### 3. Improvements to the Public Realm

March 17, 2022

*Note: Language from the Board's draft of rules update is highlighted in yellow.*

Figure xxx. Example of appropriate new alley repaving.

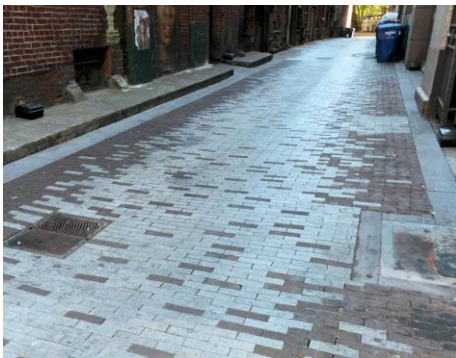
**Commented [NG10]:** Looking back at this it sounds confusing. Needs rewording

**Commented [JO11]:** ???

**Commented [NG12R11]:** PSB10015 is the Certificate of Approval number for approved installation at Nord and Pioneer Passage. It may be clearer to include the diagram and list the products approved. I will try to get those to you.

**Commented [JO13R11]:** Will make the changes when we get the PSB.

Figure xxx. Typical 3 globe pedestrian light fixture with bracket mounted traffic signal (left), 5 globe pedestrian light fixture at Pioneer Square Park (center left) Aladdin lamp streetlight (center right) and post top mounted traffic signal (right)

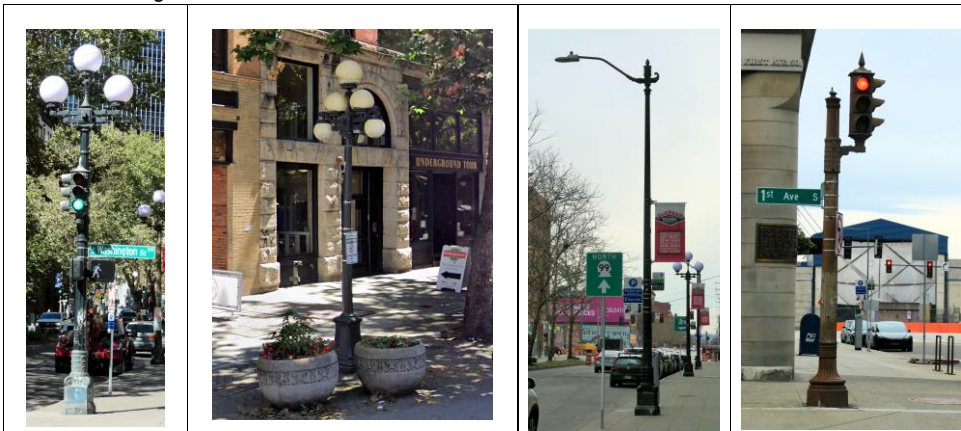
**Commented [NG20]:** Clarify traffic signals.

**Commented [NG21]:** I think that we need to add to the context that there are bronze Chief Seattle bases. I was also thinking about adding the history of the poles. 1908 the 3 globe and 5 globe with base shown in the photo of 5 globe below were used. The ones between the buildings and Pioneer Park are believed to be original. Then in 1925 the bronze bases were added. The three globe fixtures on the poles were replaced in the 70's but they are the same design as the original 1908 poles and bases remain from 1925. Many have been updated with new LED bulbs.

**Commented [NG22]:** Add Retain bronze Chief Seattle Bases bases. (some were filled with concrete and SCL says they are not salvageable.) Need to add to retain bronze and when replacement is found necessary by the Board they must be replaced with new bronze Chief Seattle Bases

**Commented [JO23]:** We will expand the figures to highlight the bases and better illustrate pole design.
